DEVELOPMENT APPLICATION

PDPLANPMTD-2026/058584

PROPOSAL: Additional Carpark (Business & Professional Services)
& Lot Consolidation

SUBJECT: Engineers Direction (02/03/2026)

SHEET:	SITE PLAN
SCALE:	1:200
TOTAL SHEETS:	7
SIZE:	A1
PROJECT No:	23E99-164
SHEET:	C101
REV:	1

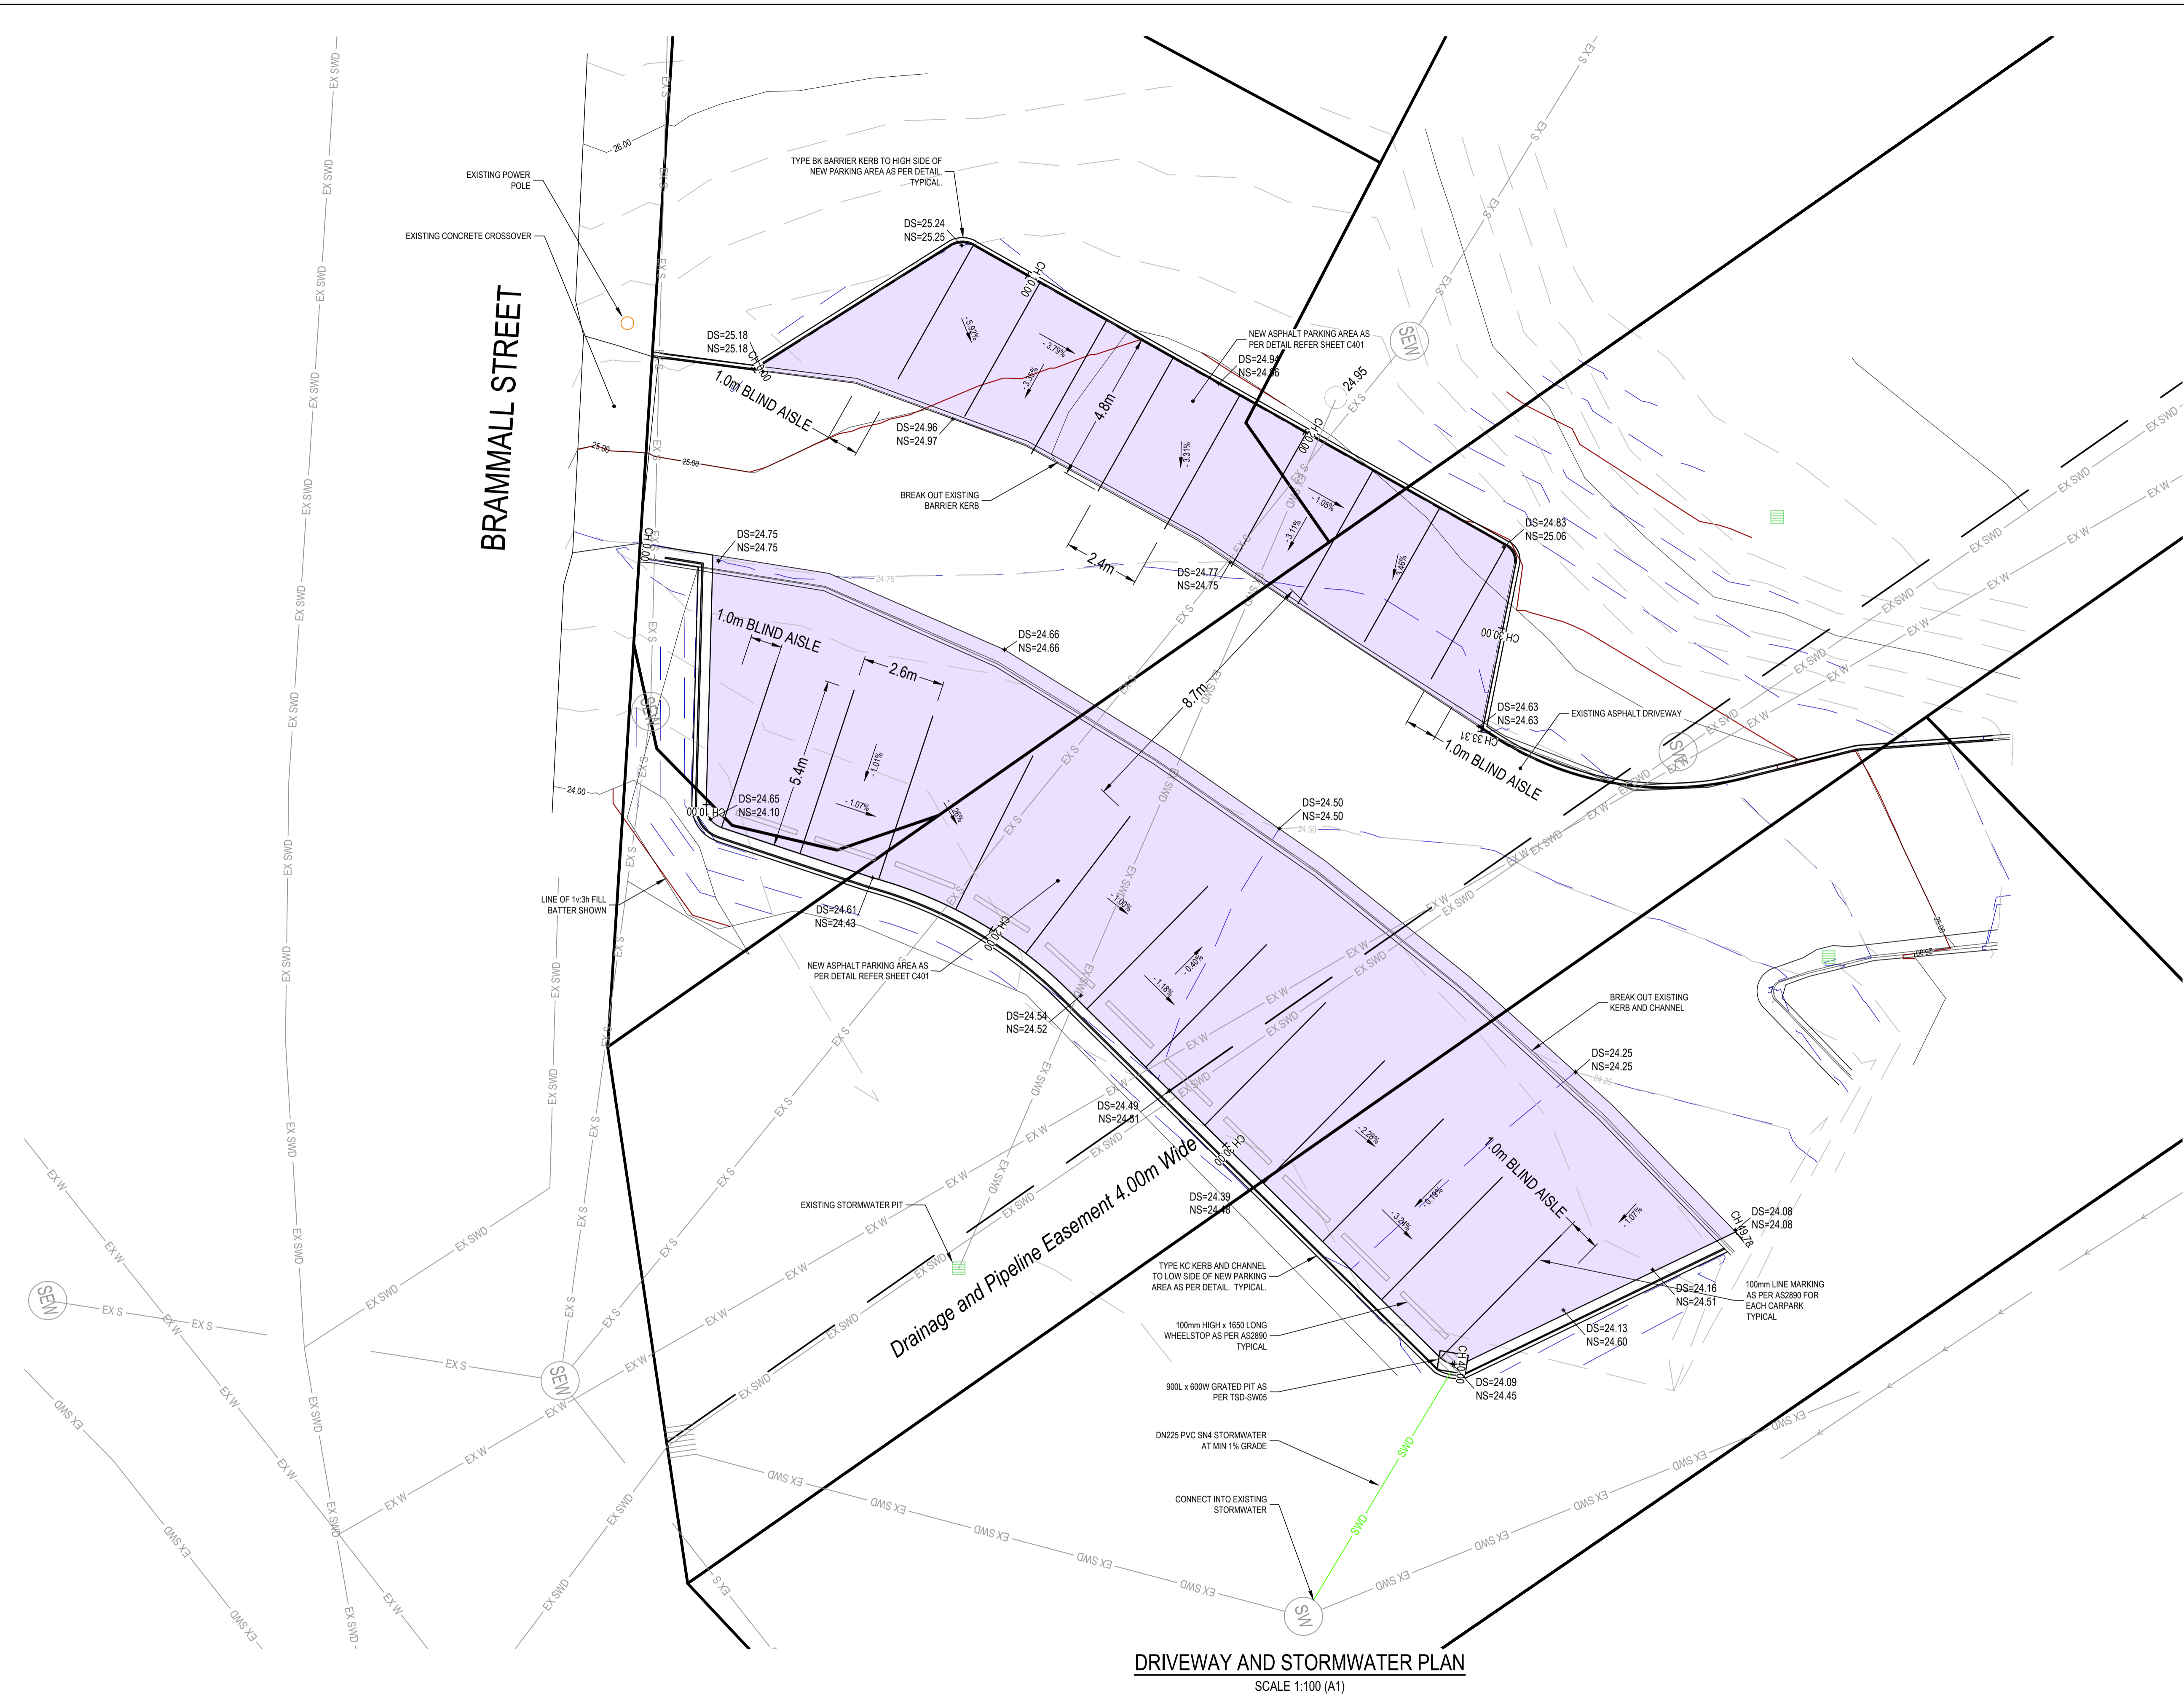
- Engineering design documents by Aldanmark 23E99-164 - sheet C101 - Rev 1 – 06/06/2024
- Correspondence from Clarence City Council - PDPLANPMTD-2026/058584
- Other relevant documentation Tasmanian Planning Scheme clause C2.6.5 P1

Verto Engineers and Project Managers has assessed the carpark design and have concluded that footpaths are not required. The reasons for this decision are noted below and are in response to clause C2.6.5 P1 of the Tasmanian Planning Scheme:

- The characteristics of the site:
 The site is an existing carpark that has no provisions for separate pedestrian access. The design follows the basic principles of what already exists on site, i.e. a shared access for traffic and pedestrians. The design is an addition to the existing carpark – essentially, it is an overflow carpark. This is a low speed environment.

- The nature of the use:
 The carpark is not a public carpark. It is intended for the employees of the DECYP. As such, it will be utilised by people familiar with the usage of the area.

- The number of parking spaces:
 The design incorporates two parking areas, one of which has 9 parking spaces and the other of which has 11 parking spaces.

- The frequency of vehicle movements:
 As noted above, the parking is intended for employee use. Hence it is expected that it will be all day parking with vehicles arriving early in the morning and leaving in the late afternoon. Outside these times it is not expected that there will be very much traffic movement.

- The needs of persons with a disability:
 This carpark has not been designed for the use of people with disabilities.
- The location and number of footpath crossings:
 There are no footpath crossings incorporated into this design.

As noted above, the design incorporates two parking areas, one of which has 9 parking spaces and the other of which has 11 parking spaces. The area of the 11 parking spaces is set approximately 4m back from the main access. This gives pedestrians in this area ample room to walk whilst maintaining a safe distance from the main thoroughfare. This is similar to the method that is already in use in the existing carpark.

The location of the access ways or parking aisles is shown on drawing 23E99-164 sheet C101 Revision 1.

No specific devices for the safety of pedestrians are included in this design other than the 4m wide area - away from the main thoroughfare - incorporated with the 11 parking spaces as noted above.
